Historic District Commission MEETING AGENDA

Monday, February 9, 2026 - 6:00 PM
Council Chambers, Easton Town Office
14 S Harrison Street

- 1) **Application Number:** 2025 - 1625 / HD 26 - 04
Applicant: Crosby & Associates, LLC
Location: 52 S. Washington Street (Foundation of Hope Inc.)
Tax Map 0104, Grid 00EA, Parcel 1463, Lot 2
Zoning District: CB
Request: New construction of a two-story commercial training building with other facility improvements including the construction of an off-street parking area with seven (7) spaces.

Figure 2 Previously Approved Signage

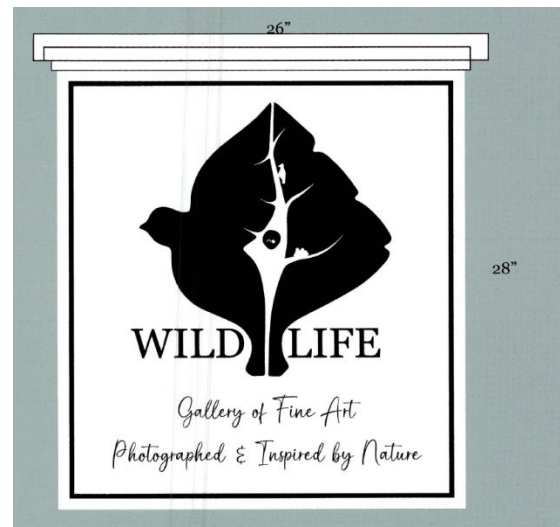
On June 9, 2025 the Commission approved the installation of a similar hanging sign at this location (*Figure 2*). Given the configuration of this building and the number of signs requested, the Planning Commission reviewed this request and approved the sign as proposed. The bracket for this sign needed to be moved up in order to accommodate the required eight feet of clearance between the sign and the sidewalk.

Staff supports a **conditional approval** of this application by the Commission. In order to comply with the Zoning Ordinance requirements for signage on buildings with multiple businesses accessed by a common entrance, the Planning Commission must approve the sign's placement and size. In addition, the bracket may need to be raised to provide the required eight feet of clearance between the bottom of the sign and the sidewalk. Consistent with the HDC Guidelines, all bracket connections must be installed through mortar joints.

1. The hanging sign shall be mounted with connection through a mortar joint.
 2. The applicant shall obtain approval from the Planning Commission.
 3. The top of the sign shall be aligned with the hanging sign that was approved by the Historic District Commission in 2025 (#25 - 1469)
-
